Road Safety Audit Report

**Mixed-Use Development,
Hills Showground Station Precinct**

Issue 2: June 2021

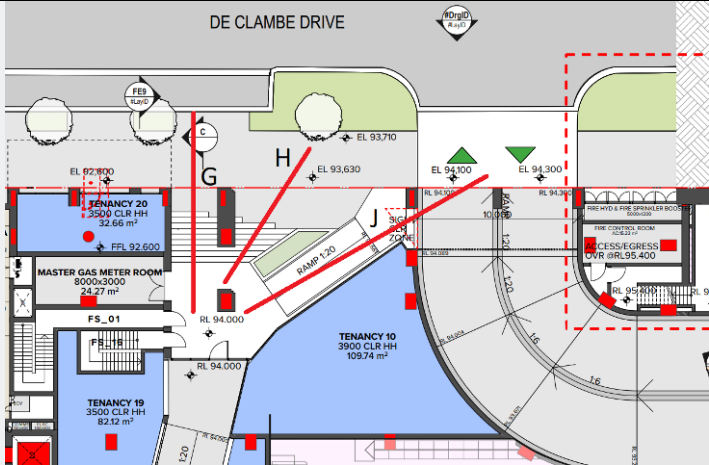
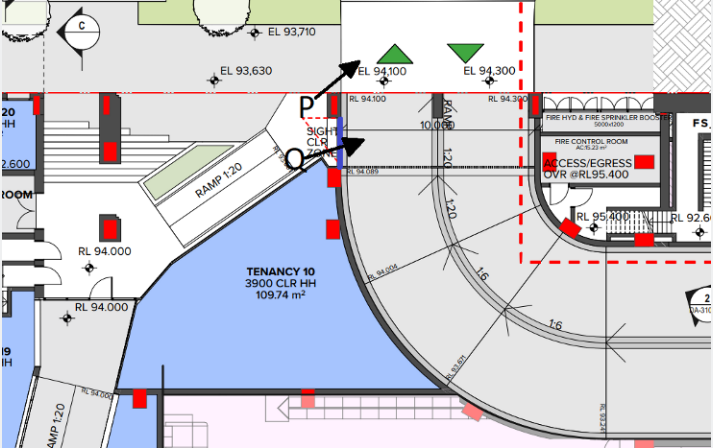
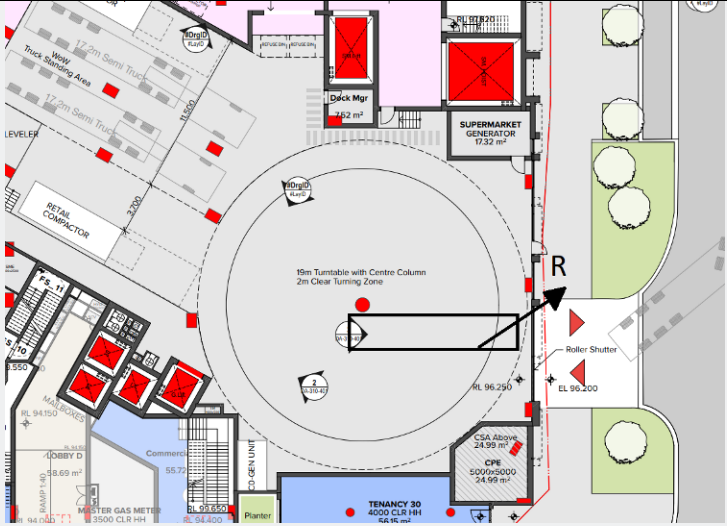
Ref No.	Photos / Site Description / Safety Issue	Description of risk to road safety (Reason why this is a safety issue)	Road Safety Audit Category	Probability	Severity	Risk Rating
1a	 <p>Above: Extract from the ground level plan showing the various pedestrian access-egress points from the mixed-use development.</p>	<p>The mixed-use development will have several access-egress points for pedestrians. These may influence pedestrian-decisions on road crossing movements, including whether they conform and use designated zebra crossings, or resort to jaywalking. Jaywalking movements introduce the risk of <i>vehicle-pedestrian</i> crashes. They may also involve pedestrians emerging into moving traffic from obscured locations such as from behind sight-obstructing trees or stopped/parked vehicles and buses.</p> <p>Examples of pedestrian crossing decisions are discussed as follows (following page) with respect to the design extract (ground floor level) to the left.</p>	Pedestrian infrastructure	Yearly	Serious	Medium

Ref No.	Photos / Site Description / Safety Issue	Description of risk to road safety (Reason why this is a safety issue)	Road Safety Audit Category	Probability	Severity	Risk Rating
1a (cont)	 <p>Above: Extract from the ground level plan showing the various pedestrian access-egress points from the mixed use development.</p>	<ul style="list-style-type: none"> The main north-south walkway at the western end of the site offers good connections to the zebra crossings at A, D and E and as such, the zebra crossing layout and the walkway are complementary. By contrast, the walkway leading to the Doran Drive/ De Clambe Drive intersection (point B) leads pedestrians to a point which is quite distant from any marked foot crossing. Pedestrians may resort to uncontrolled crossing movements over this intersection. The walkway to point C would be advantageous for pedestrians moving to or from buses at this bus stop. However, there are no other convenient onward journeys from this point. Similarly, the staircase at F leads pedestrians to the indented parking bay, but is quite distant from the zebra crossing at E. Pedestrians emerging at this point may resort to jaywalking. This includes those moving to the railway station on the southern side of Mandala Parade. 	Pedestrian infrastructure	Yearly	Serious	Medium

Ref No.	Photos / Site Description / Safety Issue	Description of risk to road safety (Reason why this is a safety issue)	Road Safety Audit Category	Probability	Severity	Risk Rating
1b	 <p>Above: Extract from the upper-level plan showing the various pedestrian access-egress points from the mixed use development to De Clambe Drive.</p>	<p>Further to item 1a, there are also pedestrian access-egress points from the upper level.</p> <p>Examples of pedestrian crossing decisions are discussed as follows with respects to the design extract (upper floor level) to the left.</p> <ul style="list-style-type: none"> The 1:20 ramp from RL 94.000 to the southern footpath of De Clambe Drive leads pedestrians directly into the outbound lane from the basement car park. If the clear sight triangle/ zone is unobstructed (ie. clear space), this may even allow pedestrians to emerge suddenly into the path of the outbound vehicle. The pedestrian may also resort to a diagonal and prolonged crossing path over the driveway ramp. This would have increased exposure to vehicle-pedestrian crashes. Further to the above point, even if the pedestrian enters the footpath first before crossing the driveway, they may emerge from behind the sight-obstructing column (red rectangle). The column may obscure them from the visibility of outbound drivers. 	Pedestrian infrastructure	Yearly	Serious	Medium

Ref No.	Corrective Action Response (CAR)	Priority for action (To be completed by Project Manager)	Residual risk (if any)
1	Publicly accessible plaza has been redesigned to conduct the pedestrians to the safe crossing points.	Immediate	N/A
2	Pedestrian sight lines and car sightlines have been incorporated.	Immediate	N/A
3	Mirrors and flashlights have been provided.	Immediate	N/A
4	Truck size has been decreased to 12.5m from 17.5m. This has a positive result on the swept path of the trucks existing the loading dock.	Immediate	N/A
5	Trees will be regularly maintained to ensure sightlines are not interrupted.	Immediate	N/A
Project Manager / Sponsor Name		Poonam Chauhan	Signature
Concurring Client Name		Greg Colbran	Signature
